**GENOA CHARTER TOWNSHIP
PLANNING COMMISSION
PUBLIC HEARING
MARCH 14, 2022
6:30 P.M.
AGENDA**

Attention:	Kelly Van Marter, AICP Planning Director and Assistant Township Manager
Subject:	Innovation Interchange PUD – Highway Sign Review #1

Attention:	Kelly Van Marter, AICP Planning Director and Assistant Township Manager
Subject:	A&J Cartage – Special Land Use and Site Plan Review #2
Location:	1247 Fendt Drive – east side of Fendt Drive, north of Grand Oaks Drive
Zoning:	IND Industrial District

**Re: A&J Cartage
Site Plan Review No. 2**

DESIGNED BY: ST
 DRAWN BY: JS
 CHECKED BY:
 SCALE 1" = 80'
 JOB NO. 21-542
 DATE 2/1/2022
 SHEET NO. 4

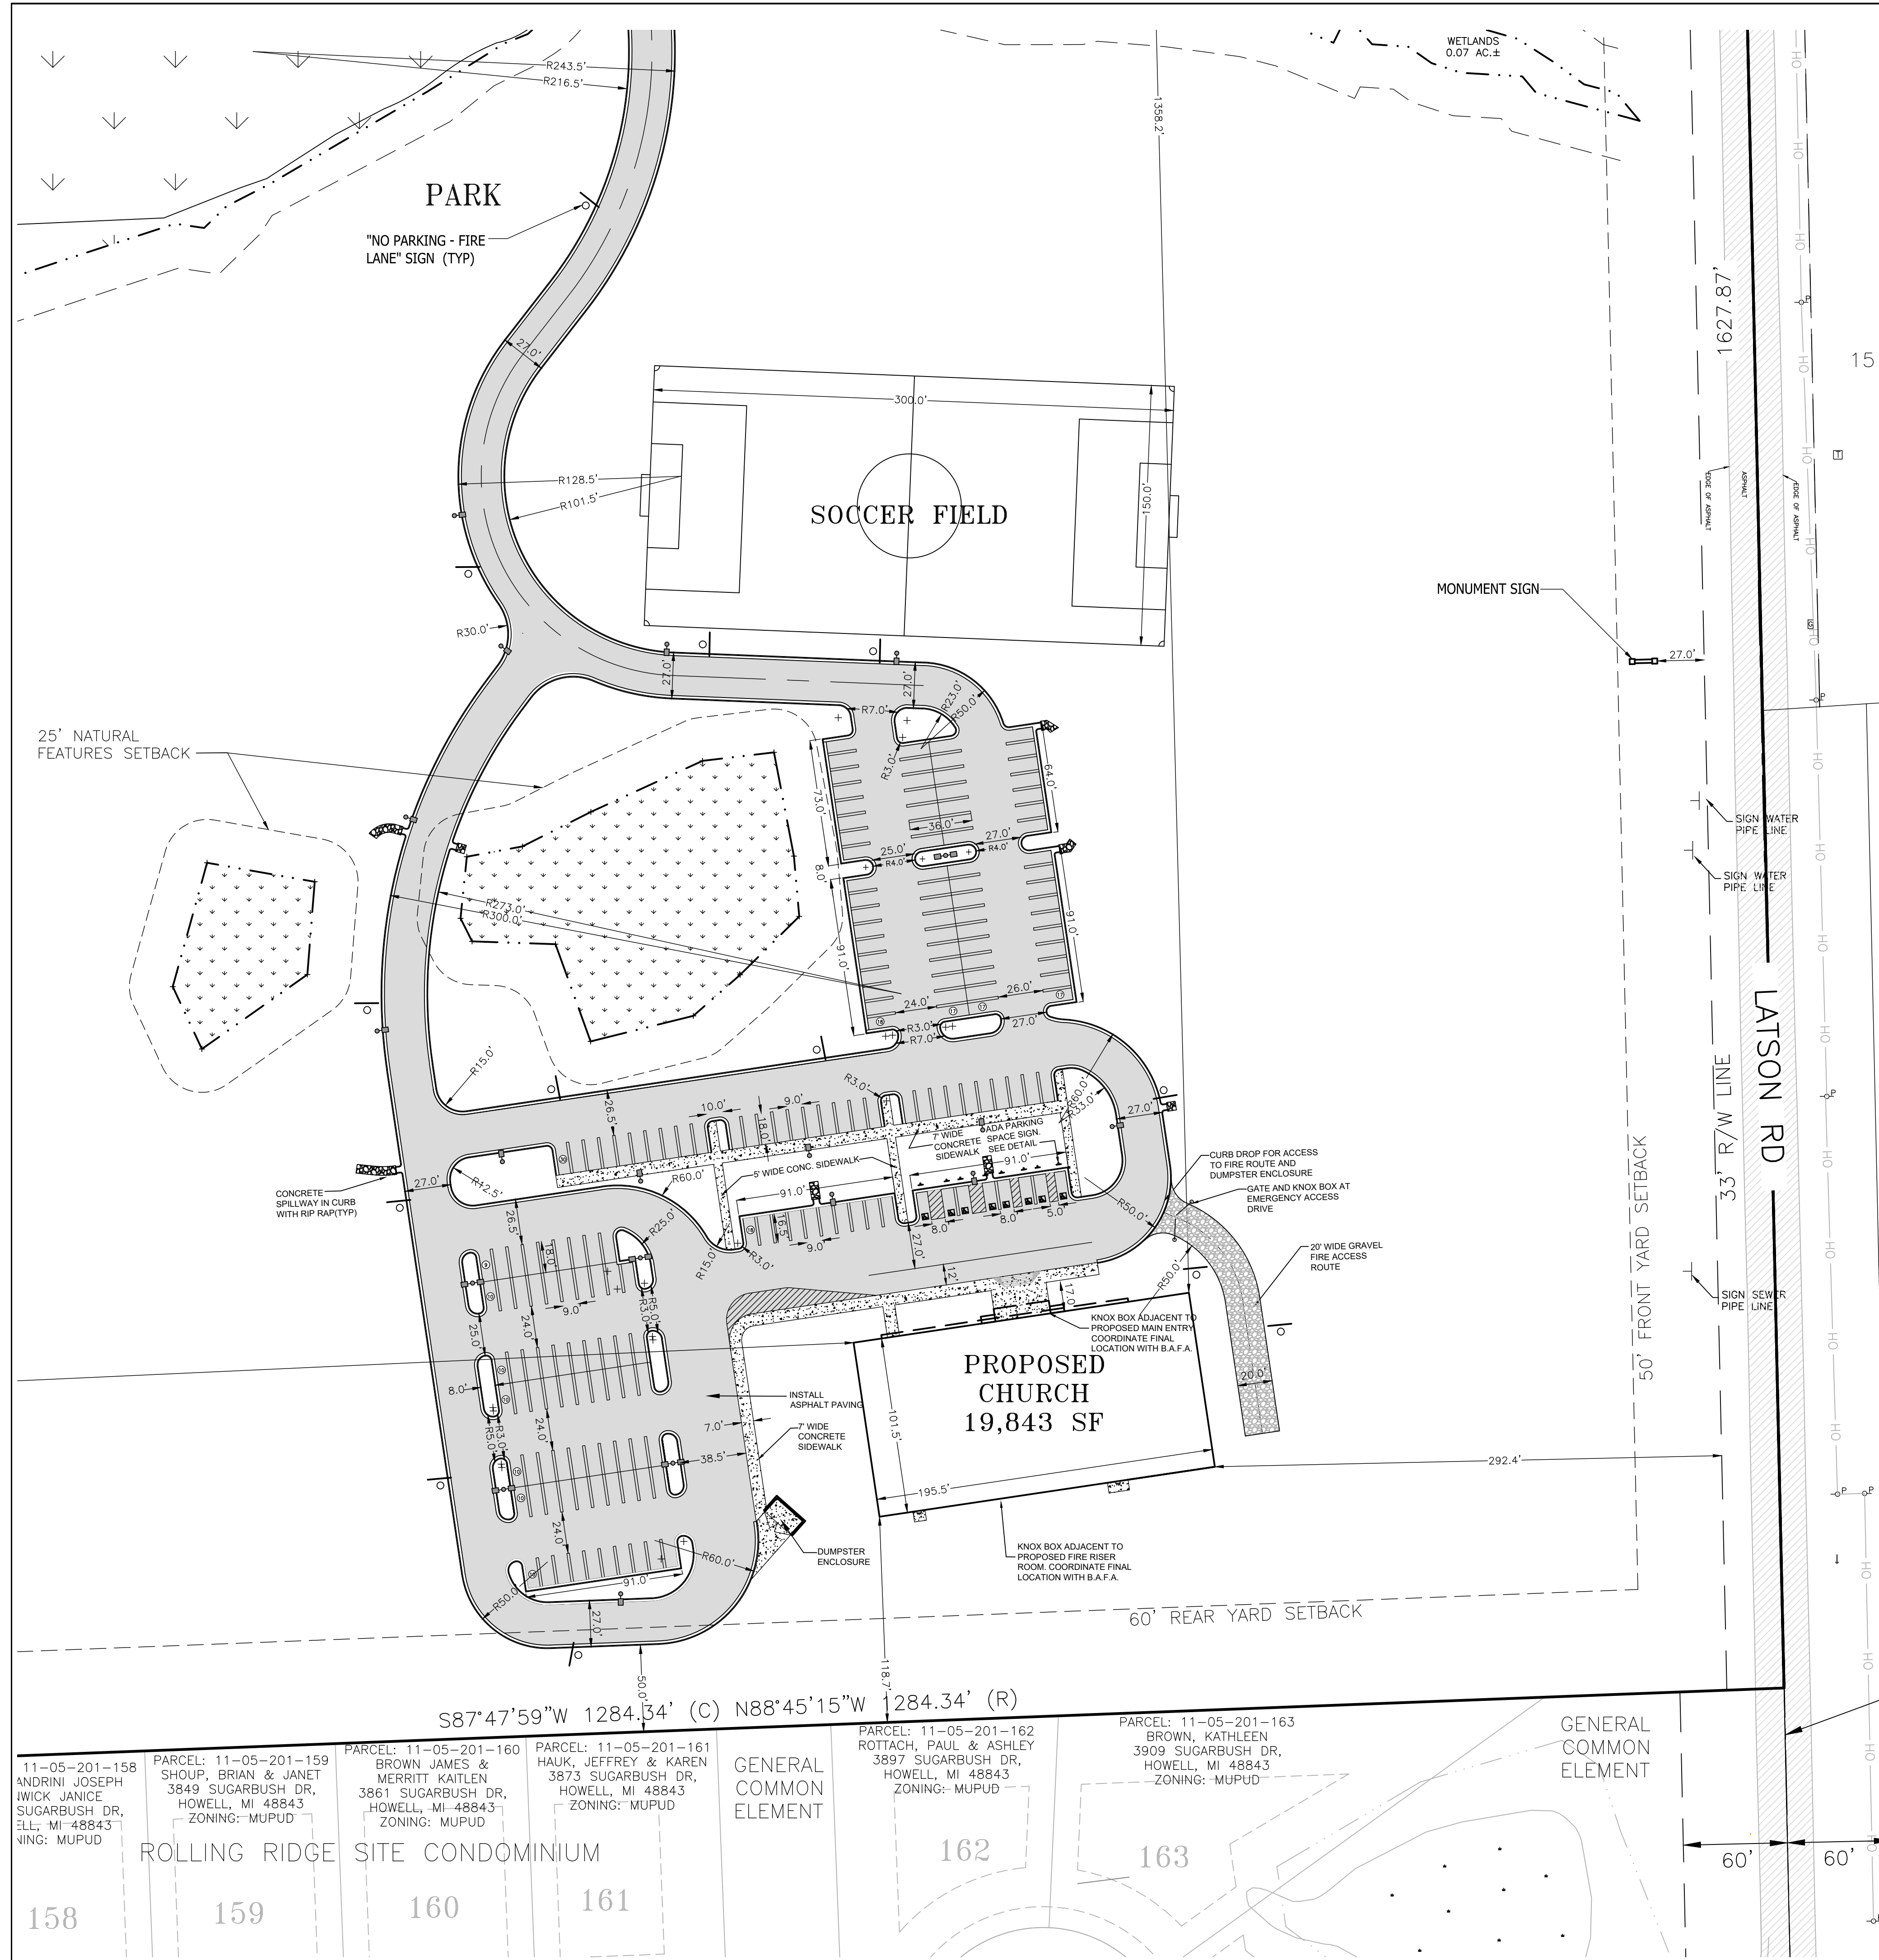
The notes on Sheet 4 identify a seating capacity of 506, which results in a minimum lot area requirement of 4 to 5 acres. The 46.5-acre site easily exceeds the minimum lot area required by this criterion.

A truck turning template is included on Sheet 4. As previously noted, the template indicates that large vehicles will cross over curbs in the southerly portion of the site.
